Hu Yu Residence

Addition and Remodel

Summary of Comments on 2201-224-SUB1-PLANS_review.pdf

SHEET TITLE:
Site Plan, Notes

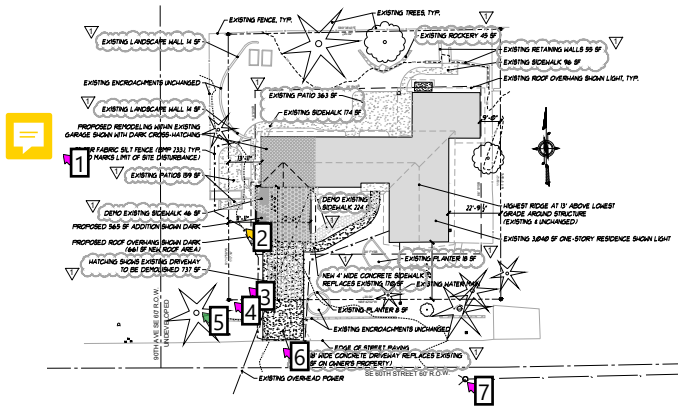
Silt fencing must be installed on private property and may not encroach into City ROW. As shown, silt fencing currently encroaches into ROW on the southern and western fronts.

Number: 2 Author: Land Use Planning Review (molly.mcguire@mercerisland.gov) Subject: Sticky Note Date: 6/6/2022 10:04:24 PM
 No leave encroachment is allowed into minimum side yard setback on interior lot lines. Please show minimum side yard setbacks per MICC 19.02.020(C)(1)

If jogging side yard setbacks, clearly show where jog occurs and show that the sum meets the 17% of lot width requirement. In this case, the minimum side yard setback is 33% of the aggregate side yard setbacks since the variable side yard setbacks do not apply.

Provide additional information to clarify how and where the storm runoff from the driveway will flow to.

1) Identify the construction access. If the existing driveway will be used as access, please note it.

2) Identify stockpile/staging area. Stockpile/staging area must be located on private property.

Number: 5 Author: Tree Review (john.kenney@mercergov.org) Subject: Sticky Note Date: 5/26/2022 9:58:03 AM
 Call out no new gravel in the area near city tree. No silt fence allowed in right of way. But 3' orange fence should be put up in right of way to protect area near this cedar from compaction during construction.

No concrete or pavers in ROW.

Show and provide a note that all storm drain inlets within 50' of the site must have inlet protection. Provide detail for storm drain inlet protection.

Number: 8 Author: Land Use Planning Review (molly.mcguire@mercerisland.gov) Subject: Sticky Note Date: 6/6/2022 10:20:10 PM
 Show lot slope calculation on plans. High and low points and the shortest vertical distance between.

SHEET TITLE:
Site Plan, Notes

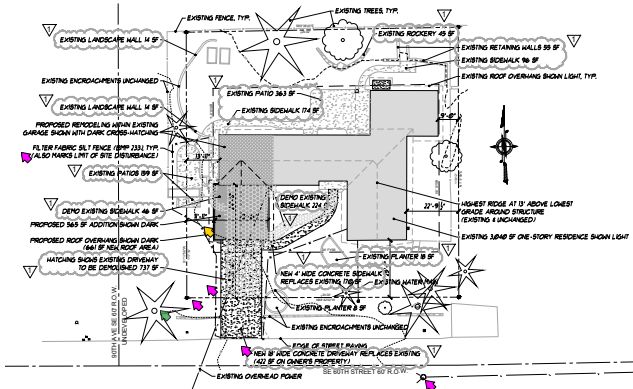
Include table **R402.1.1** from the wsec on the permit plan set.

SHEET TITLE:
Floor & Roof Plans
Building Sections

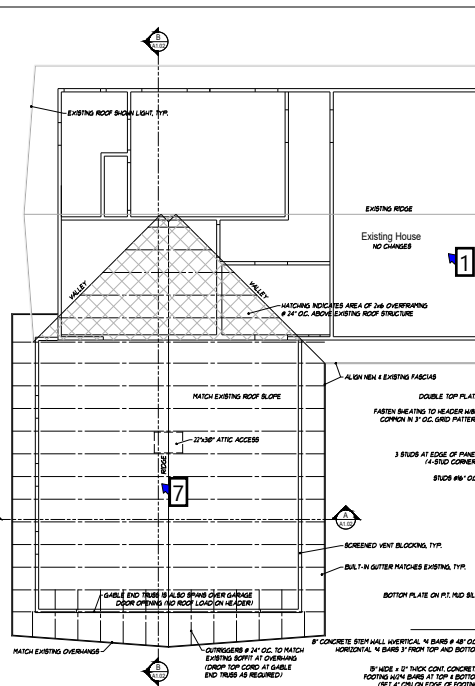
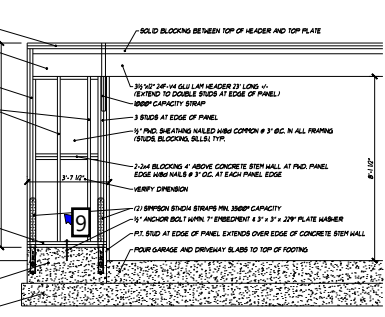
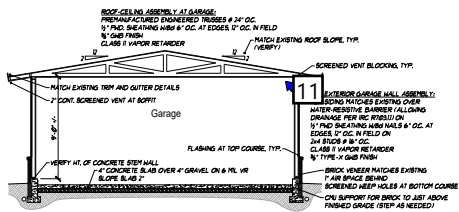
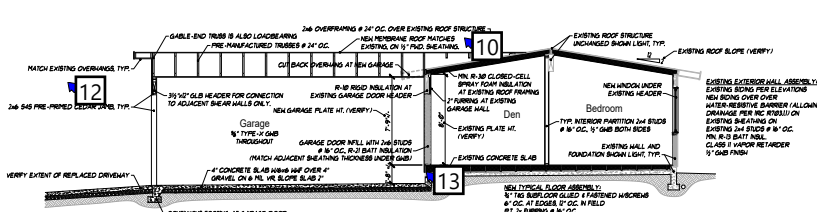
<p>Number: 1</p>	<p>Author: Building Plan Review (jacob.halverson@mercerisland.gov)</p>	<p>Subject: Sticky Note</p>	<p>Date: 6/22/2022 10:11:47</p>
<p> Provide foundation plan and locate all new and existing (presumed) extents/depths and foundations.</p>			
 <p>Number: 2</p>	<p>Author: Building Plan Review (jacob.halverson@mercerisland.gov)</p>	<p>Subject: Sticky Note</p>	<p>Date: 6/22/2022 10:07:18</p>
<p> Room as detailed (Den) resembles a sleeping room, provide this window as egress.</p>			
 <p>Number: 3</p>	<p>Author: Building Plan Review (jacob.halverson@mercerisland.gov)</p>	<p>Subject: Sticky Note</p>	<p>Date: 6/22/2022 10:06:36</p>
<p> Provide an additional smoke detector in this room.</p>			
 <p>Number: 4</p>	<p>Author: Building Plan Review (jacob.halverson@mercerisland.gov)</p>	<p>Subject: Sticky Note</p>	<p>Date: 6/22/2022 10:05:29</p>
<p> Provide note that provides compliance per: R302.5: Openings and penetrations through the walls or ceilings separating the dwelling from the garage shall be in accordance with Sections R302.5.1 through R302.5.3.</p>

<p>Number: 5</p>	<p>Author: Building Plan Review (jacob.halverson@mercerisland.gov)</p>	<p>Subject: Sticky Note</p>	<p>Date: 6/22/2022 10:03:39</p>
<p> Provide all separation requirements per IRC R302.6 on plan or building section for clarity for dwelling/garage fire separation. Garage separation requirements include 5/8" type X between garage and habitable space above, 1/2" between garage and habitable space on garage side of walls, and a 20 min rated or solid core entry door with a self-closing device.</p>			
 <p>Number: 6</p>	<p>Author: Building Plan Review (jacob.halverson@mercerisland.gov)</p>	<p>Subject: Sticky Note</p>	<p>Date: 6/22/2022 10:04:29</p>
<p> dedicated mechanical space found elsewhere in the residence. Please locate major mechanical equipment.</p> <p>If Mechanical equipment appears to interfere with drive aisle and If mechanical equipment is to be in garage, show location and provide bollard/bollards or approved alternative to protect mechanical equipment in driveway per M1307.3.1. If curb provided note requirement per M1307.3 requiring 18".</p>

<p>Number: 7</p>	<p>Author: Building Plan Review (jacob.halverson@mercerisland.gov)</p>	<p>Subject: Sticky Note</p>	<p>Date: 6/22/2022 10:09:07</p>
<p> Provide attic ventilation per (R806.1) & calculations unless insulation is applied on the under-side of roof sheathing. (R806.5)</p>			
 <p>Number: 8</p>	<p>Author: Building Plan Review (jacob.halverson@mercerisland.gov)</p>	<p>Subject: Sticky Note</p>	<p>Date: 6/22/2022 10:03:02</p>
<p> Provide heat detector. R314.2.3 A heat detector or heat alarm rated for the ambient outdoor temperatures and humidity shall be installed in new garages that are attached to or located under new and existing dwellings. Heat detectors and heat alarms shall be installed in a central location and in accordance with the manufacturer's instructions.</p>			
 <p>Number: 9</p>	<p>Author: Building Plan Review (jacob.halverson@mercerisland.gov)</p>	<p>Subject: Sticky Note</p>	<p>Date: 6/22/2022 10:17:39</p>

<p> Indicate any shearwalls, provide shearwall design and schedule to resist any lateral forces garage is subject to. Provide holddown details, locations, and design if required - on foundation or framing plan.</p>			
 <p>Number: 10</p>	<p>Author: Building Plan Review (jacob.halverson@mercerisland.gov)</p>	<p>Subject: Sticky Note</p>	<p>Date: 6/22/2022 10:16:29</p>
<p> Provide a typical over framing detail of connection between existing sheathing/roof system and new proposed roof sheathing and system. Specify nailing at a minimum at connections.</p>			
 <p>Number: 11</p>	<p>Author: Building Plan Review (jacob.halverson@mercerisland.gov)</p>	<p>Subject: Sticky Note</p>	<p>Date: 6/22/2022 10:19:49</p>
<p> Provide truss to top plate detail structural detail.</p>			
 <p>Number: 12</p>	<p>Author: Building Plan Review (jacob.halverson@mercerisland.gov)</p>	<p>Subject: Sticky Note</p>	<p>Date: 6/22/2022 10:26:55</p>

<p> R301.1.3: Work done in this area affects structural. Specification and details of a new header and supports traced to foundation/ shear transfer will be required with supporting calculations. Prescriptive approach to design if conforming entirely to WSRC, and calculations for any elements which are designed per WSBC to be provided.</p> <p>If this is not done prescriptively a registered design professional will need to do design and submit calculations with a key plan.</p>			
 <p>Number: 13</p>	<p>Author: Building Plan Review (jacob.halverson@mercerisland.gov)</p>	<p>Subject: Sticky Note</p>	<p>Date: 6/22/2022 10:23:03</p>
<p> Provide this structural detail, at proposed new flooring to existing foundation to floor. I.e. Is this is ledger condition now?</p>

SHEET TITLE:
 Exterior Elevations
 Details

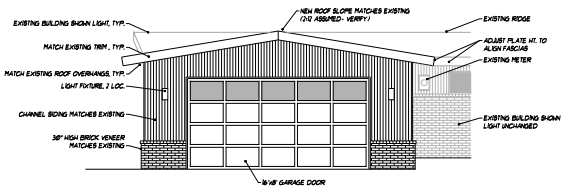
Number: 1 Author: Land Use Planning Review (molly.mcguire@mercerisland.gov) Subject: Sticky Note Date: 6/6/2022
3:00:24 PM
Provide ABE calculations

Number: 2 Author: Land Use Planning Review (molly.mcguire@mercerisland.gov) Subject: Sticky Note Date: 6/6/2022
3:00:10 PM
Provide existing and finished grades, Average Building Elevation, and ABE +30 on all elevation plans.
